APPENDIX 2

Georgia Power Company NRC Docket 50-321 Operating License DPR-57 Edwin I. Hatch Nuclear Plant Unit 1 Proposed Changes to Technical Specifications Emergency Power Systems

The proposed changes to the Plant Hatch Unit 1 Technical Specifications would be incorporated as follows:

TABLE 3.2-13

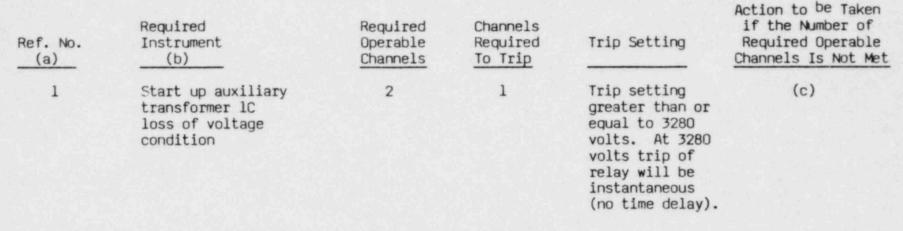
INSTRUMENTATION WHICH INITIATES ENERGIZATION BY ONSITE POWER SOURCES

- a. The column entitled "Ref. No." is only for convenience so that a one-to-one relationship can be established between items in Table 3.2-13 on items in Table 4.2-13.
- b. This instrumentation is required to be operable during reactor startup, power operation, and hot shutdown.
- c. With the number of operable channels one less than the required operable channels, operation may proceed provided the relay is removed from its case. Removing the relay accomplishes the same action as an operable relay operating to open its trip circuit.
